Office Action Summary

10/033,883

YAO ET AL.

DETAILED ACTION

Figure 9 of the Klein Patent (US_4,554,460) is shown above.

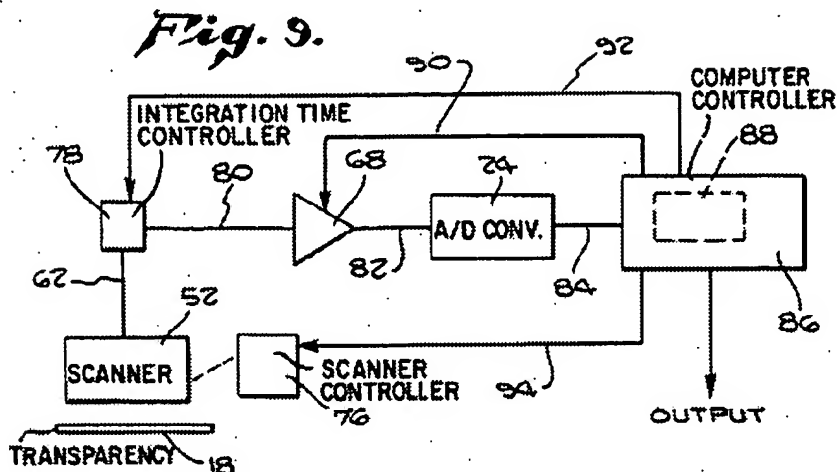
14. Claims 1, 3 and 4 are rejected because:

Klein discloses a scanning analyzer unit comprising:

A). A scanning processor unit 52 that scans the testing support 18, wherein the scanning processor unit 52 outputs a test signal 62 resulting from the scan of the testing support 18 (see Figure 9);

a signal amplifier 68 that is coupled with the scanning processor unit 52 to amplify the test signal 62, 80;

an analog/digital converter 24 that is coupled with the signal amplifier 68 and the computing unit 86, wherein the analog/digital converter 24 converts the amplified test signal 82 into a digital signal 84 that is transferred to the computing unit 86;

a computing unit 86 (see col.5, line 21) that is coupled with the scanning processor unit 52, wherein the computing unit 86 receives and analyzes the test signal 62;

a controller device 86 that is coupled with the scanning processor unit 52, wherein the controller device 86 outputs a driver signal 94; and,

a driver device 76 that is coupled with the controller device 86 and the scanning processor unit 52, wherein the driver device 76 receives the driver signal and accordingly drives the scanning processor unit 52 to accomplish the scan of the testing support 18 (see col. 5, lines 10-30), the scanning analyzer used for analyzing testing results that are obtained from a testing support for determining spectral quality of a sample under test (see col. 1, lines 6-31).

However, Klein does not teach of a scanning analyzer apparatus comprising separate computing unit and controller device for analyzing the test signal from the scanning processor unit and controlling a driver device based on the scanning processor unit output, the scanning analyzer apparatus used for analyzing testing results that are obtained from a testing support for determining spectral quality of a sample under test.

B). Klein teaches of a scanning analyzer apparatus comprising a combined computing unit and controller device 86 for analyzing the test signal from the scanning processor unit 52 and controlling a driver device 76 based on the scanning processor unit output 62 (see Figure 9; see col. 5, lines 10-30), the scanning analyzer apparatus used for analyzing testing results that are obtained from a testing support for determining spectral quality of a sample under test.

C). In view of Klein's teaching, it would have been obvious to one of ordinary skill in the art at the time the invention was made to modify Klein's apparatus by having a separate computing unit and a controller device due to the fact that such separate computing and controlling units would provide a modular system where each module can easily be replaced for repair and/or maintenance of the scanning analyzer apparatus, used for analyzing testing results that are
